# THE FIERO RECALLS

Number 84-C-08 Date 02/85

Subject: MISPOSITIONED CLAMP ON HEATER INLET HOSE

FIGURE 1

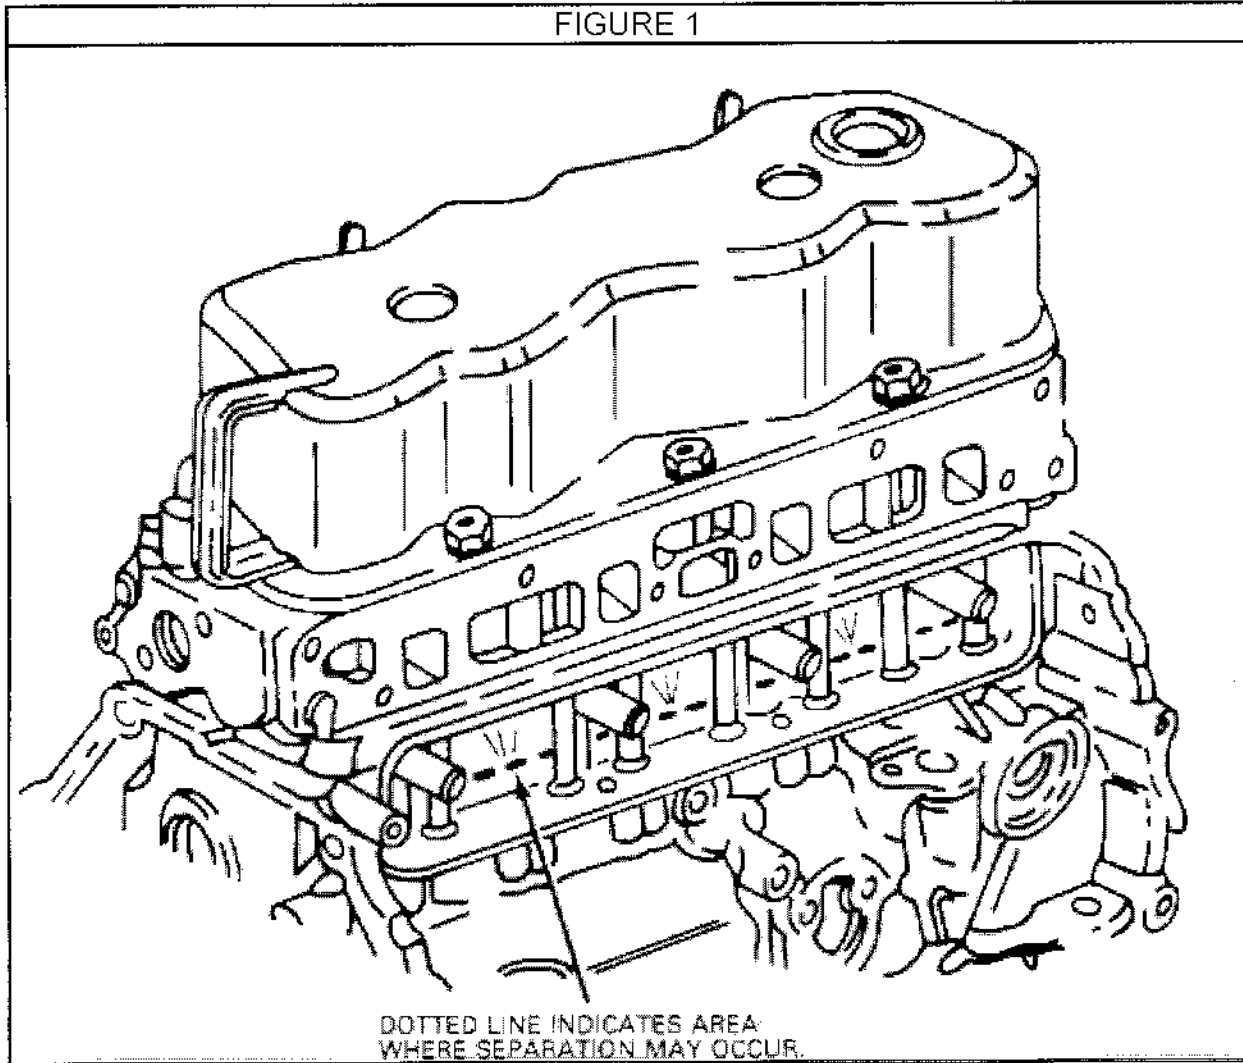
General Motors has determined that certain 1984 Pontiac Fiero models were assembled with a mispositioned upper retaining clamp on the heater inlet hose. This could allow the hose to loosen and separate from the heater inlet pipe. A separated hose could cause a loss of engine coolant which could result in premature engine failure.

3. Loosen upper clamp on heater inlet hose.
4. Reposition hose beyond second rib on heater inlet pipe (see Figure 1).
5. Position clamp between the two inlet pipe ribs and retighten to 2 N-m or 16 in.lbs.
6. Reinstall heat shield.
7. See PART II (page 3) for installation of campaign identification label.

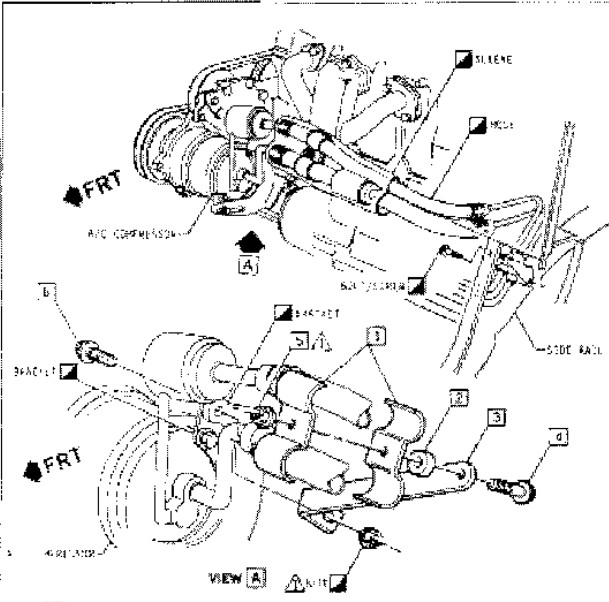
General Motors has determined that some 1986 Pontiac Fiero model vehicles equipped with 2.5L engines and air conditioning (A/C) may experience fatigue cracking of the A/C hose assembly near the compressor.

To prevent the possibility of this condition occurring, an A/C hose assembly support bracket will be installed on all involved vehicles. Additionally, the A/C hose assembly will be replaced as required.

3. Remove (2) existing bolt/screws securing coupled hose assembly to side rail (refer to illustration).
4. Remove and save existing staple from existing sleeve.
5. Slide sleeve away from compressor to allow attachment of clamp to hose assembly.
6. Remove existing nut and bolt/screw, securing existing brackets to compressor.
7. Loosely attach clamps, bracket and spacer as shown in illustration.

NOTICE: BE SURE CLAMPS ARE PROPERLY ORIENTED WITH HOSE DIAMETERS.

8. Correctly position bracket and clamps and torque nuts to 40-60 Nm (30-45 ft.lbs.).
9. Slide existing sleeve back into position.

FIGURE 1

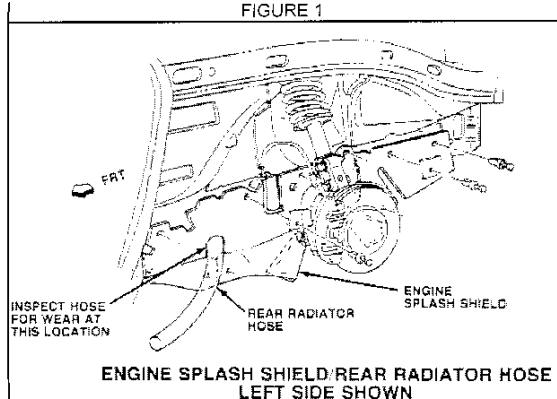
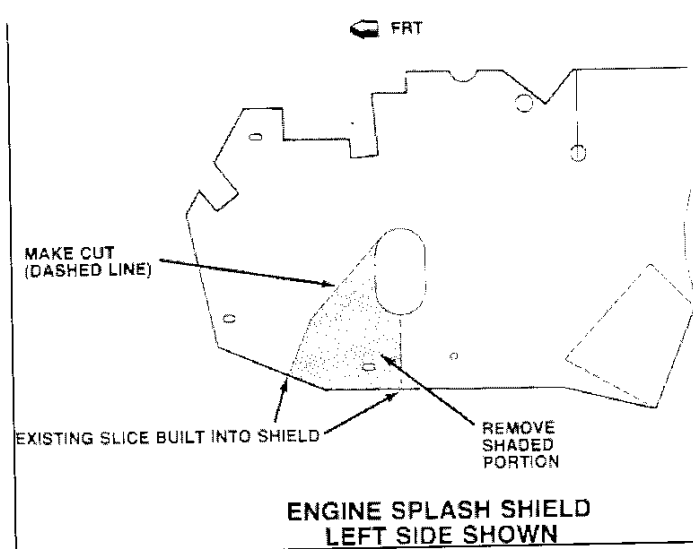
General Motors has determined certain 1985-86 Fiero model vehicles equipped with a V6 engine could exhibit an interference condition between the engine splash shields and the engine cooling system hoses. Over time, this condition could result in wear of the coolant hose(s), possibly causing a coolant leak.

To prevent the possibility of this condition occurring, it will be necessary to inspect involved vehicles and ensure there is adequate clearance between the coolant hoses and engine splash shields. Additionally, coolant hoses will be inspected for wear and replaced if necessary.

2. Rework (cut) left-hand splash shield on all subject vehicles as shown in Figure 2.
3. On right side, trim away engine splash shield as necessary to eliminate any potential contact with hose.
4. Install Campaign Identification Label.

ILLUSTRATION A - 1984-86 MODELS

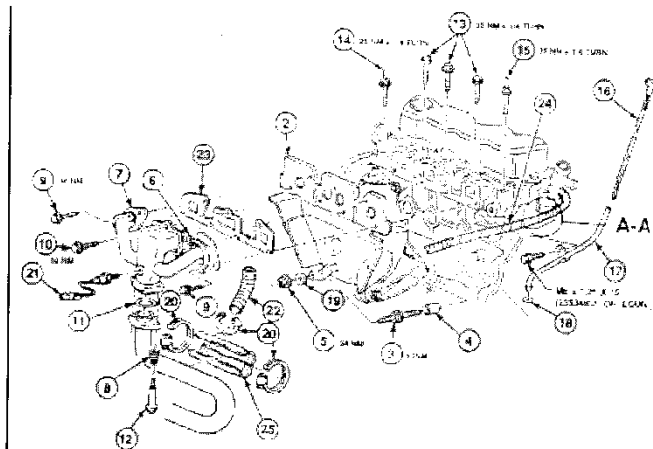
An interaction of the engine compartment environment in 1984-88 Pontiac Fiero's and maintenance or service related factors results in the potential for engine compartment fires.

If combustible materials come in contact with the exhaust manifold, an engine compartment fire can result. Engine compartment fires can spread to the passenger compartment and cause injury to occupants.

To reduce the possibility of this condition occurring, all vehicles will have changes made in their underhood environment. Specifically, all vehicles will have a manifold barrier installed, a minor change to decklid sealing, and a general inspection (and repair as necessary) of underhood fluid and wiring systems. Additionally, 1984-86 model year vehicles will have a new exhaust manifold installed to bring them up to 1987-88 specifications.

Description	Part Number	Quantity/ Vehicle
Service Kit (1984-85-86) (ILLUSTRATION A)	10184936	1
Service Kit (1987) (ILLUSTRATION B)	10184937	1
Service Kit (1988) (ILLUSTRATION C)	10184938	1

## ILLUSTRATION A - 1985-86 KIT

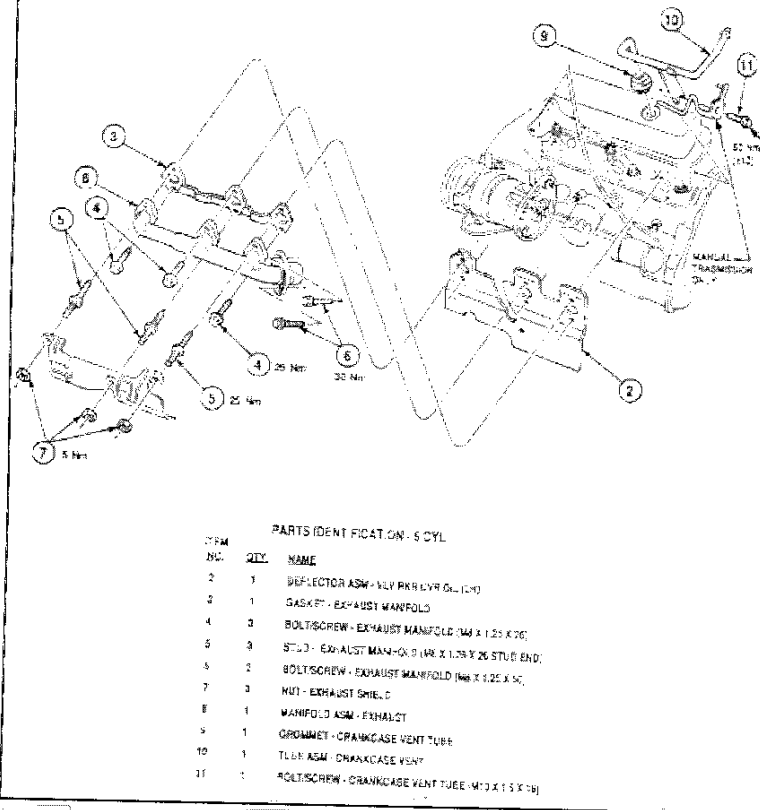
An interaction of the engine compartment environment in 1985-86 Pontiac Fiero's and maintenance or service related factors results in the potential for engine compartment fires.

If combustible materials come in contact with the exhaust manifold, an engine compartment fire can result. Engine compartment fires can spread to the passenger compartment and cause injury to occupants.

To greatly reduce the possibility of this condition occurring, all vehicles will have changes made in their underhood environment. Specifically, all vehicles will have a manifold deflector installed, a minor change to decklid sealing, a PCV system modification and a general inspection (and repair as necessary) of underhood fluid and wiring systems. Additionally 1985-86 model year vehicles will have a new exhaust manifold installed to bring them up to 1987-88 specifications.

Description	Part Number	Quantity/ Vehicle
Service Kit (1985-86) (ILLUSTRATION A)	10154765	1
Service Kit (1987-88) (ILLUSTRATION B)	10154787	1

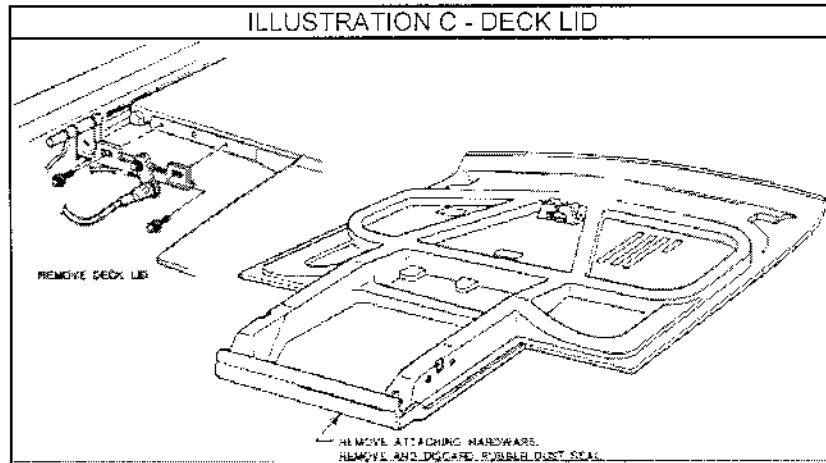
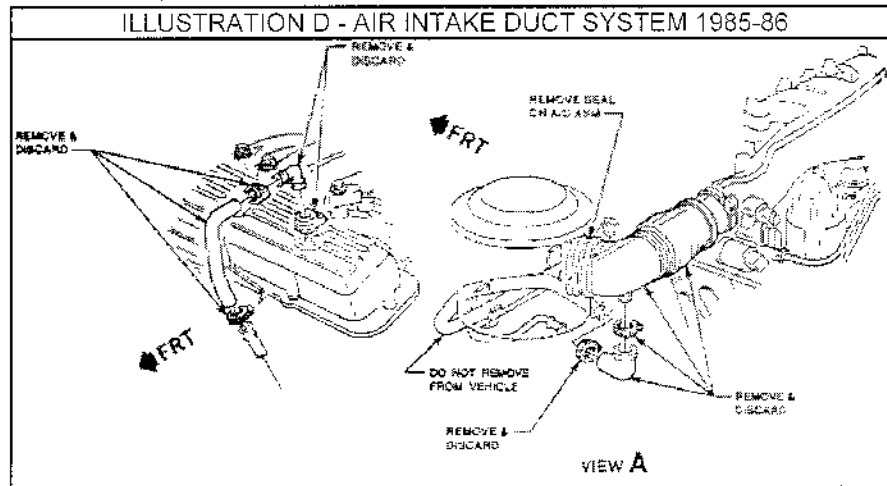
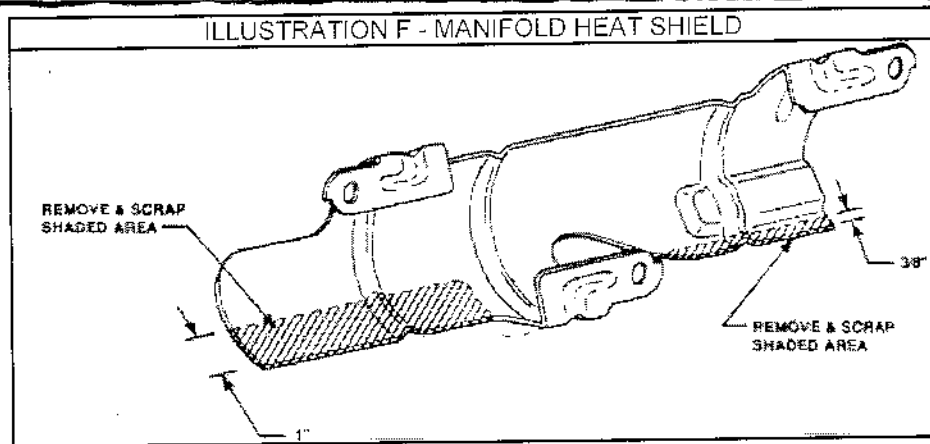
To reduce the effects of fluid leaks which may lead to engine compartment fires, Pontiac dealers will do the following at no charge:

- a. Remove outboard grille panels, and disconnect BOTH positive and negative battery cables (remove the battery on vehicles equipped with air conditioning).

- b. Remove rear engine compartment lid. Remove rubber dust seal and retaining clips from leading edge (front) of decklid assembly (and leave off) (ILLUSTRATION C).

- r. Modify (ILLUSTRATION F) and install outer manifold heat shield (dimensions for modification on illustration).
- s. Reattach cradle and torque cradle bolts according to the applicable Fiero Service Manual procedure. Remove jack stands. Lower vehicle.

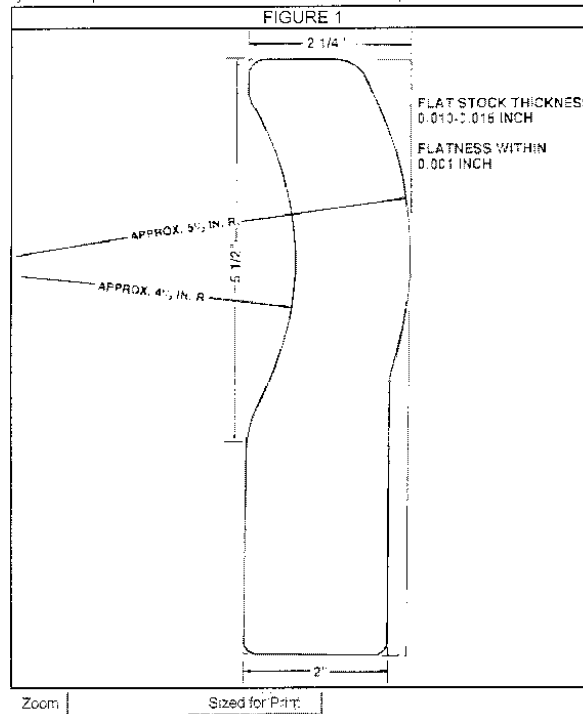
The 1982-88 Firebird, 1984-87 Fiero, and 1984-88 6000 STE vehicles with the rear disc brake calipers are designed to automatically adjust. Some vehicles may experience increased rotor to lining clearance if the rear calipers do not adjust fully. The following is a procedure that can provide manual adjustment and can be repeated, if necessary.

1. Raise vehicle.
2. Remove rear wheels.
3. Reinstall two lug nuts on each axle to hold rotors in place..
4. Fully apply and release the park brake three (3) times.
5. Verify that the park brake levers are in the full release position as described in the service manual.

6. Pry caliper outboard to produce a gap between outboard pad and rotor. Insert a 0.010 to 0.015 inch shim between the outer brake pad and the rotor. Suggested shim shape is shown in Figure 1.
7. Apply the park brake, trapping the inch shim between the rotor and the outer brake pad.
